SEWAGE DISPOSAL SYSTEM

P 599294B

SUBDIVISION _____ LOT _____ ROAD 1795 Butterfly Court

REPAIR - PURPOSE - SEPTIC SYSTEM HAS FAILED.

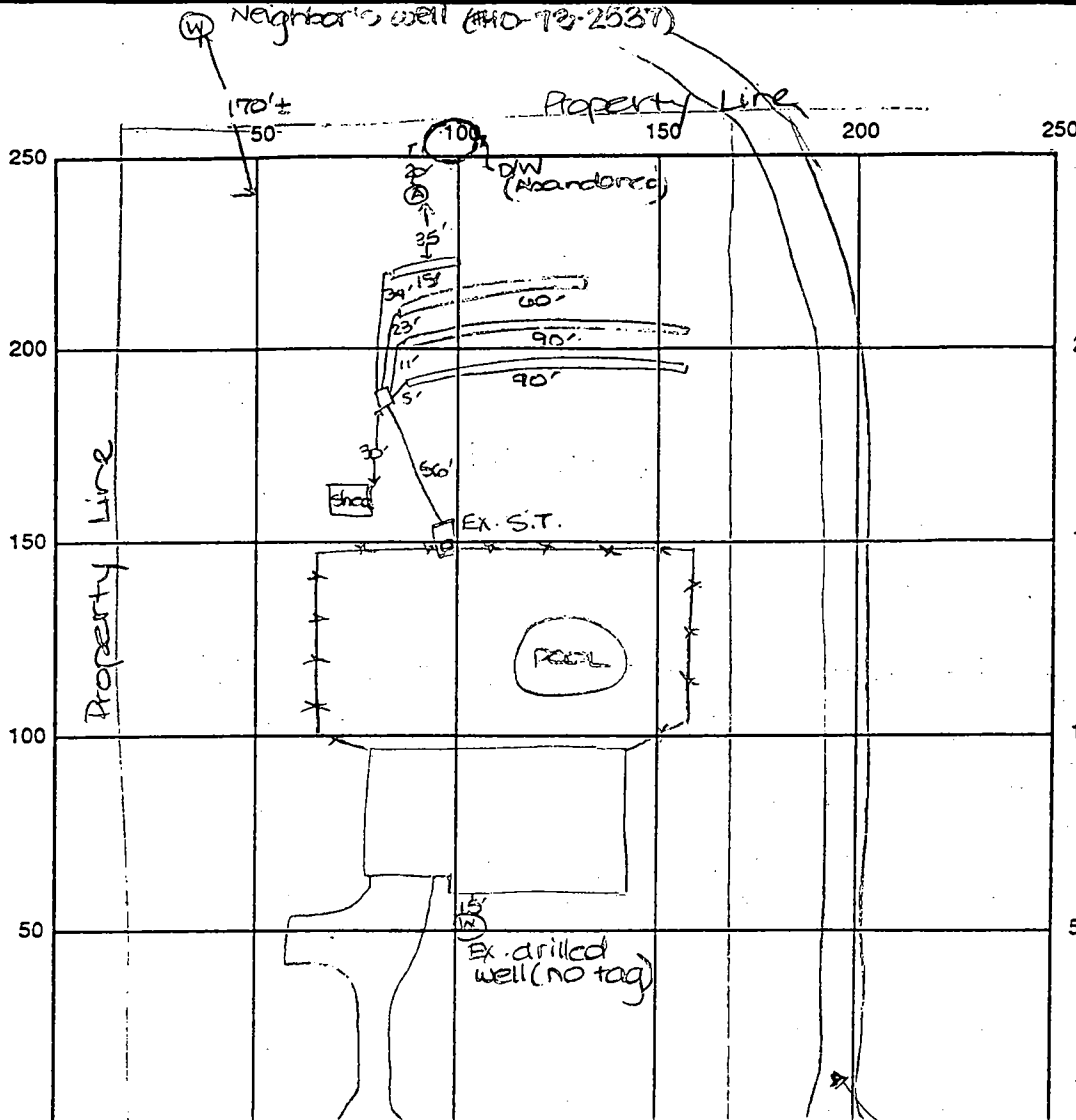
Existing drywell to be disconnected due to surrounding soil conditions
shallow replacement system to be installed
Trenches to be installed in accordance with permit requirements
Trenches to be 3' wide, inlet 3" dia, bottom 4-6' from 1'.

(A) Failed
 0'
 topsoil
 org. brn
 clay
 7'
 > 50%
 scapr
 sh frag
 200'
 Refusal

(B)
 0'
 topsoil
 org. brn
 clay
 3.5'
 pale org
 brn sd
 lm
 w/leg scapr
 sh
 8.5'
 Refusal

REMARKS: 4/13/98 A.M. OK to begin installation as specified. DKS

4/13/98 P.M. OK to continue work. DKS

4/14/98 A.M. FINAL INSP - OK to cover all work. Drywell pumped and properly abandoned. Trench (4) less than specified length due to excessive rock. -DKS
